Doc Description: Addendum 3 - Construction of Boat access on Lower Elk River

Request for Quotation
(Construction Services - Kanawha County, Lower Elk River (5) Boating Access Site Project)

Kanawha County Lower Elk River Five (5) Boat Access Ramps Project
Vendor submitted Questions and Agency Responses

WEST VIRGINIA
DIVISION OF NATURAL RESOURCES
ELK RIVER BOATING ACCESS SITES
BIG CHIMNEY
OVERALL SITE PLAN

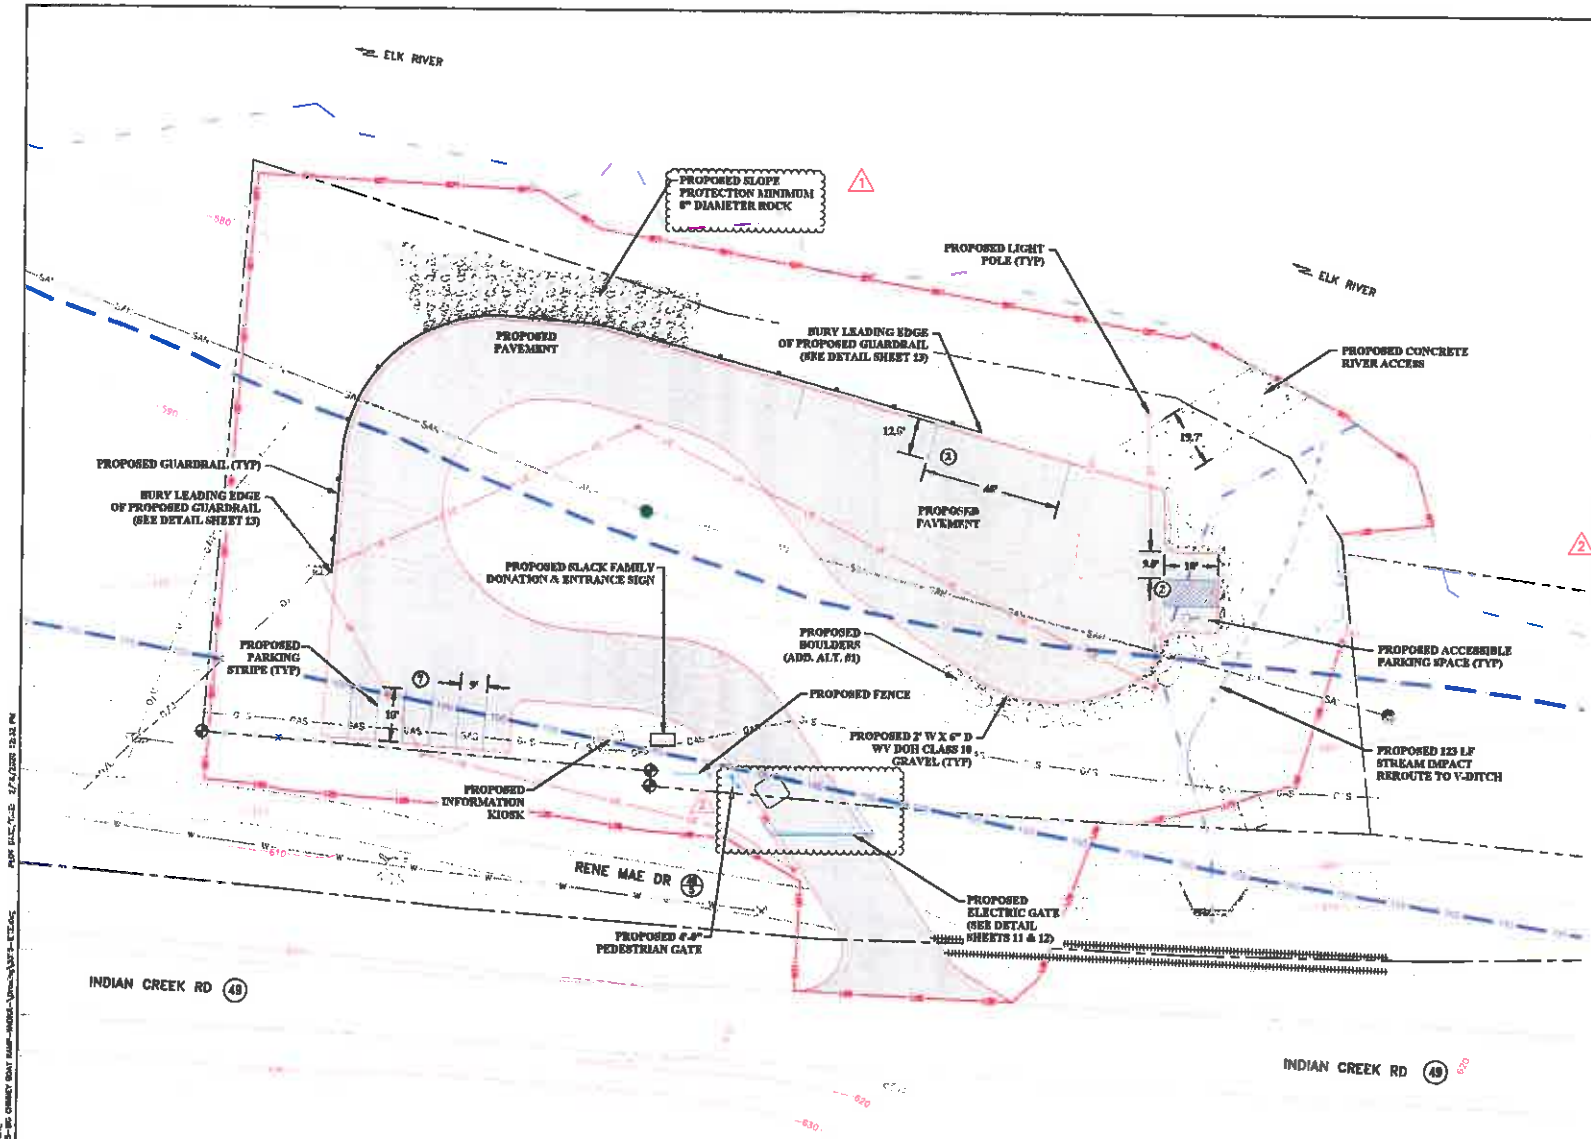
Q.4. What will command the gates to open?

A A note has been added to Big Chimney Sheet 4, Blue Creek Sheet 4 and Clendenin South Sheet 4 about the gate operations.

1. CONTOUR INTERVAL IS 2 FT.
2. ADDITIVE ALTERNATE #1: PROPOSED BOULDERS ARE TO BE APPROXIMATELY 3' WIDE AND 4' HIGH. THE BOULDERS ARE TO BE PLACED NO MORE THAN 3' APART.
3. GATE SHALL BE OF THE AUTOMATIC CLOSING TYPE AND CLOSE FROM DUSK UNTIL DAWN.
4. WHEN GATE IS CLOSED, THERE SHALL BE ACCESSIBILITY FOR EMERGENCY VEHICLES.
5. GATE SHALL ALLOW PERSONS REMAINING INSIDE GATE ONCE IT IS SHUT TO OPEN FOR EXIT.

NO.	BY	DATE	DESCRIPTION
1	DRK	8/13/2020	REVISED SLOPE PROTECTION NOTE
2	DRK	8/18/2020	REVISED GATE LOCATIONS AND ADDED NOTE

CHAIN LINK FENCE DETAIL

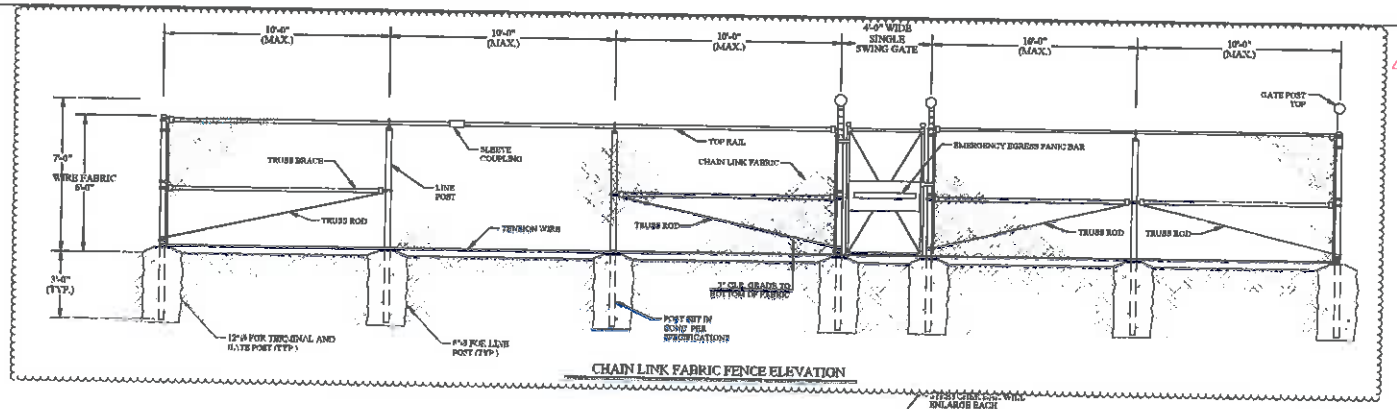
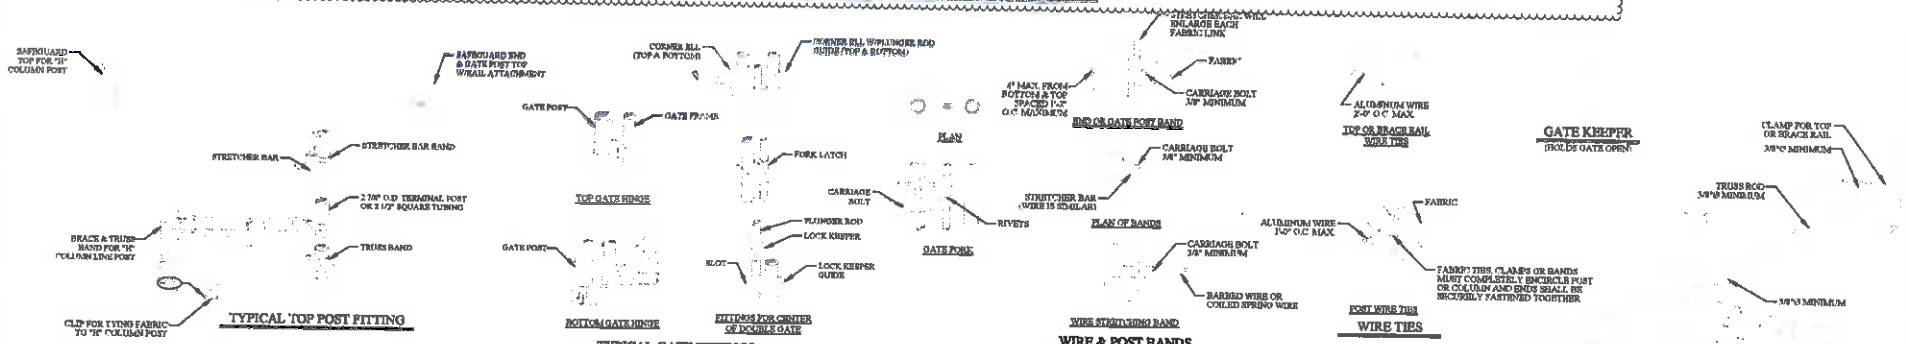
Q.1. They show both a steel external roller gate and an aluminum internal roller gate – major money difference in the two.

Q.2. Also. As the gates are located – slide gates will be difficult- the gate & operator would have to be on the outside of the fence- non secure side. Is this correc?

Q.3.The gate in the open position will slid out in to open space, not along the normal fence line. Is this correct?

A. The gate shall be aluminum.

A. The operating motor and system will be located on the interior side of the gate.

A. The gate will slide open and not along the fence line.

1. GATE SHALL BE OF THE AUTOMATIC CLOSING TYPE AND CLOSE FROM DUSK UNTIL DAWN.
2. WHEN GATE IS CLOSED, THERE SHALL BE ACCESSIBILITY FOR EMERGENCY VEHICLES.
3. GATE SHALL ALLOW PERSONS REMAINING INSIDE GATE ONCE IT IS SHUT TO OPEN FOR EXIT.

NO.	BY	DATE	DESCRIPTION
2		8/18/2020	REVISED GATE DETAIL
